RICHARD R. HORNER, PH.D.

February 15, 2008

Executive Officer and Members of the Board
California Regional Water Quality Control Board
San Francisco Region
1515 Clay Street, Suite 1400
Oakland, CA 94612
mrp@waterboards.ca.gov

Re: Response to Talking Points for NRDC Meeting, January 29, 2008

Figure 1. Scatter Plot of Runoff Volume at the Cascade Inlet Versus Rainfall Depth for All Storms from October 11, 2003, to March 31, 2006 (NS001 is the inlet station; KTRL is the Kendall-Theil-Robust Line.)

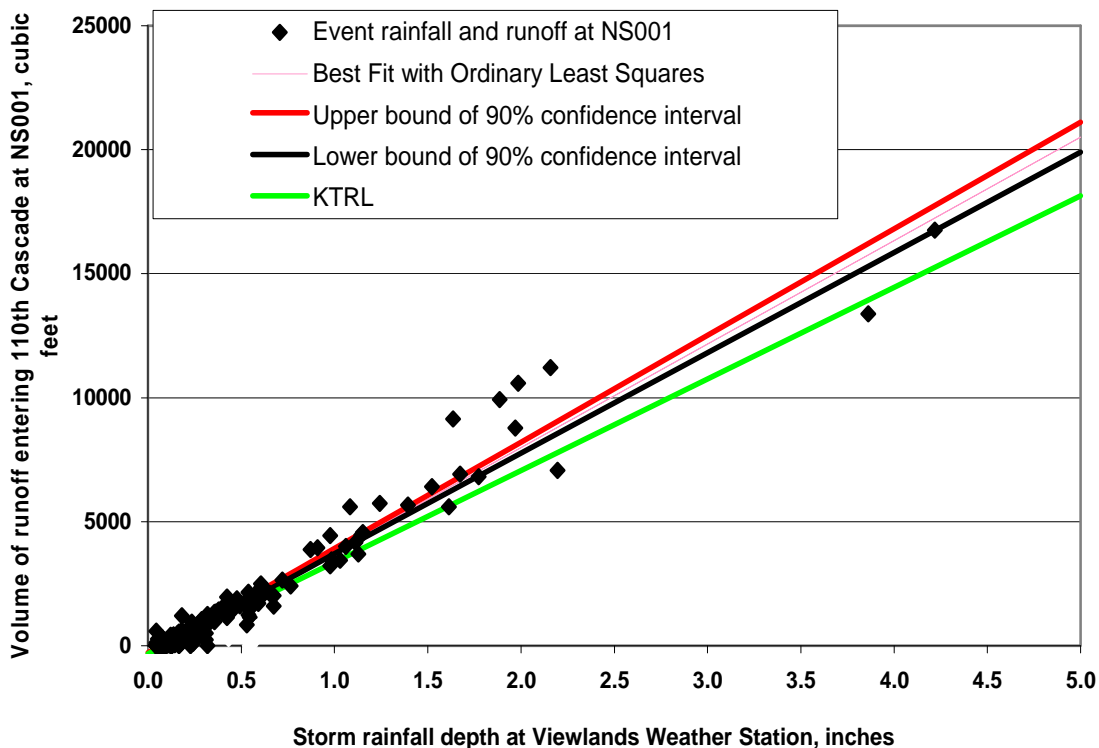
Figure 1 plots influent runoff volume versus rainfall depth for all 239 storms that occurred during the monitoring period. Several statistical regression techniques were applied to these data, the best-fit lines for two of which are shown in Figure 1. If the flow volumes are converted to water depth across the catchment, then the slope of the fitted line becomes the runoff coefficient; i.e., the ratio of runoff produced to rainfall. All regression methods considered indicate a runoff coefficient of 0.10-0.11, which is equivalent to about 1 acre of directly connected impervious surface with a runoff coefficient of 1.0. That situation, in fact, is what was observed and described above, and this regression analysis lends support to its conclusions.
